## MEMORANDUM

RE: ZP 13-1262CA/MA

**Location:** 256-258 North Winooski Avenue and 260-262 North Winooski Avenue

**Request:** Combine 256-258 and 260-262 North Winooski

PROJECT NORTH  
SITE PLAN  
Scale: 1/8" = 1'-0"

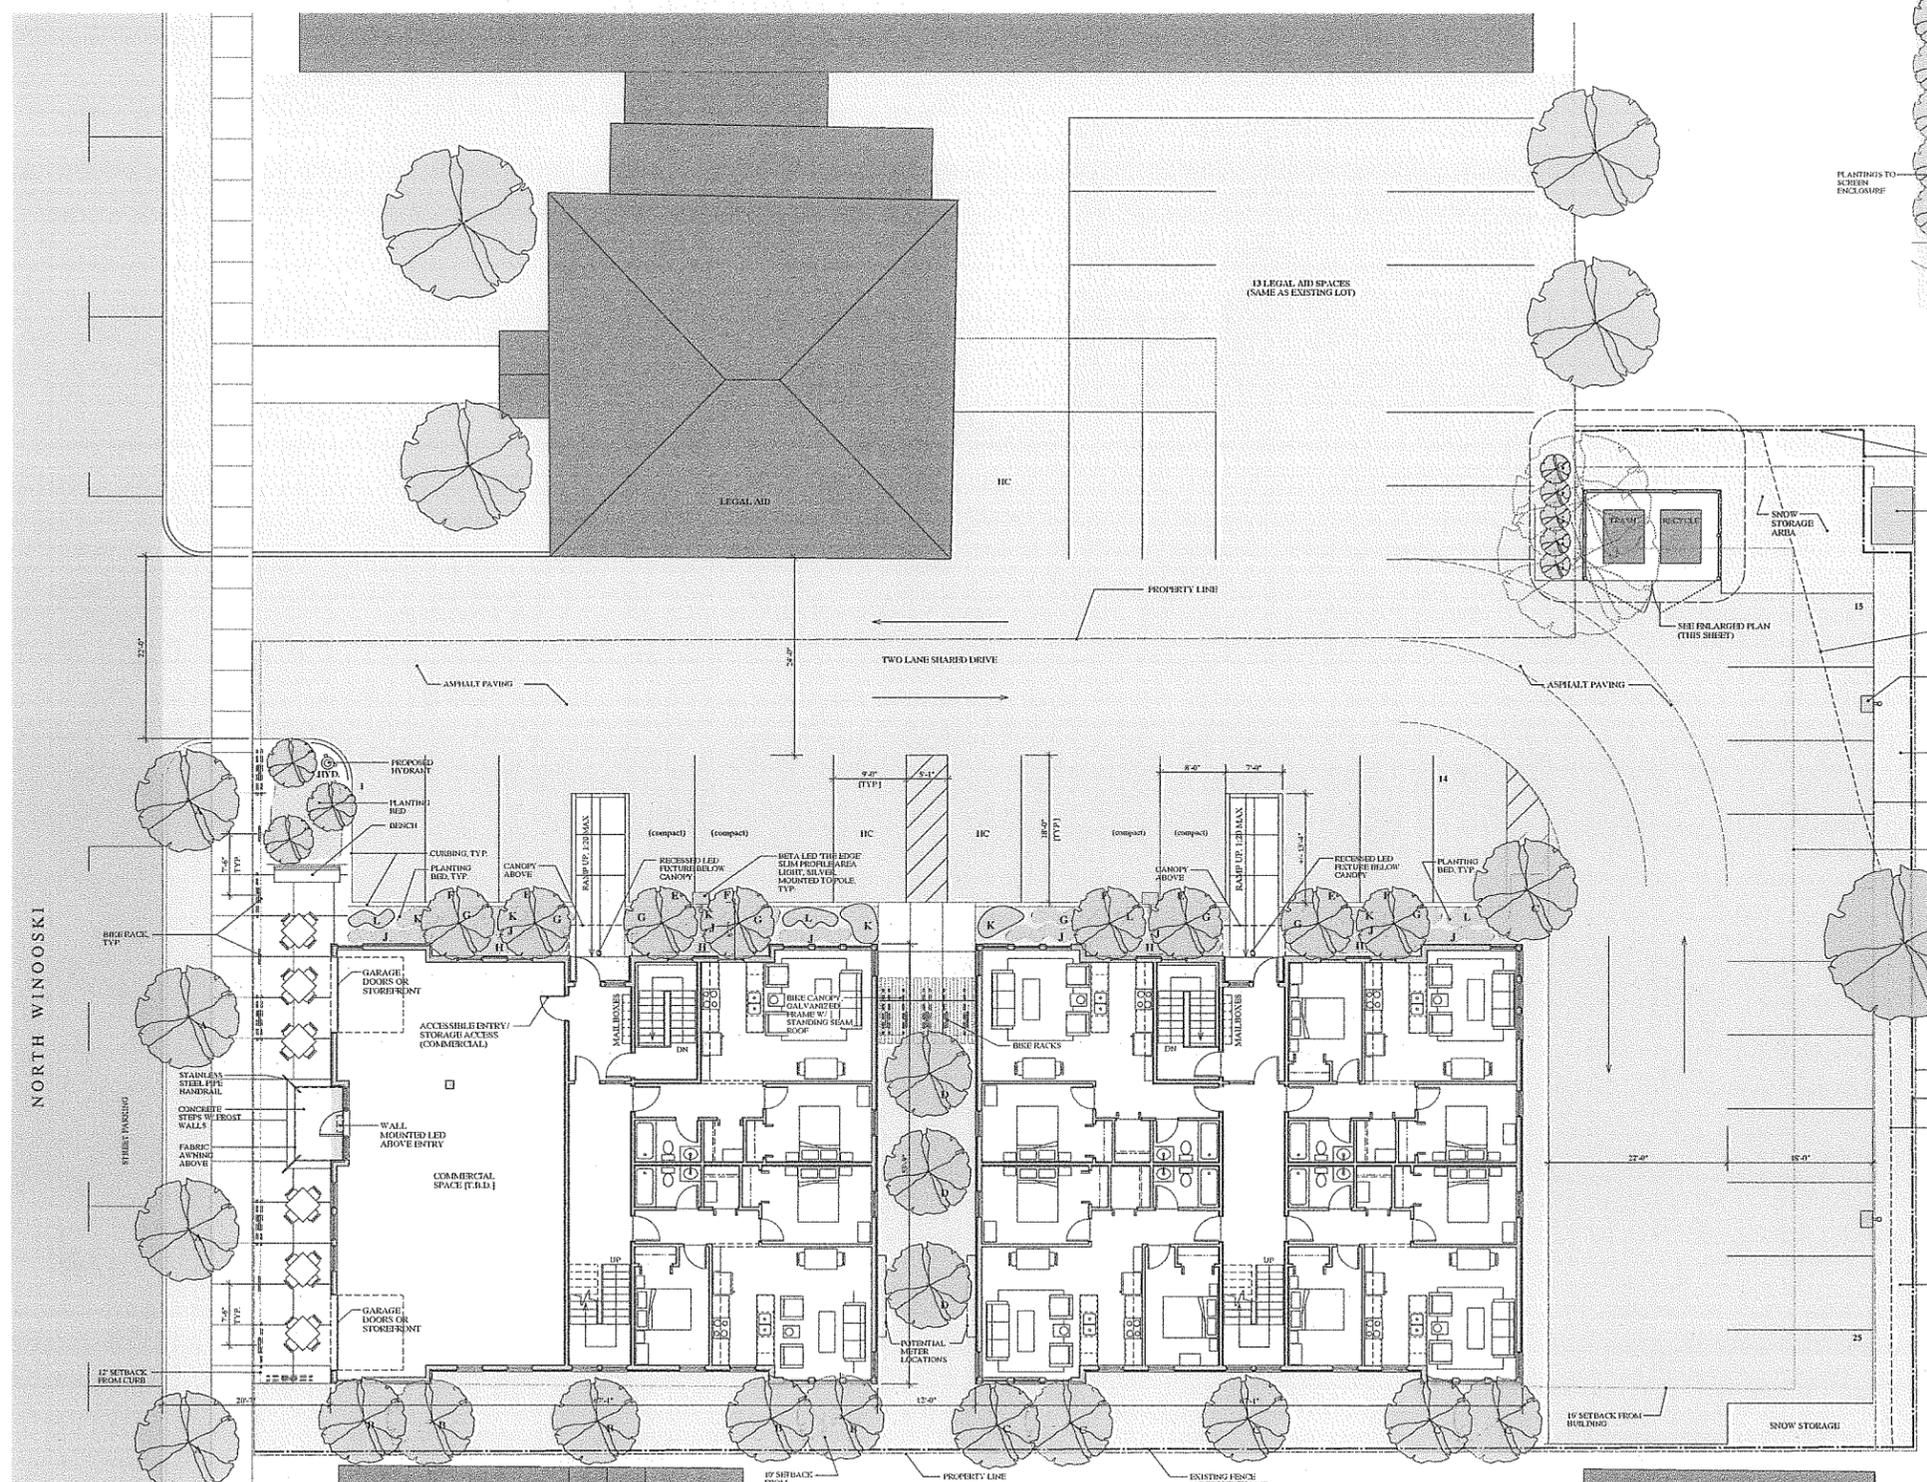
Plan L 1.0 defines significant plantings along building facades, between the buildings, and along the property line to the west. As noted in submission materials, the selection and placement of the trees in the greenbelt was guided by City Arborist Warren Spinner. The potential for headlamp glare onto abutting residential properties is eliminated with proposed relocation of existing fence.

The design of the trash enclosure is provided in a detail on plan L-1.0. **(Affirmative finding)**

2. **Prior to release of the zoning permit**, a revised site plan depicting a walkway connecting the rear building to the public sidewalk shall be submitted, subject to staff review and approval.
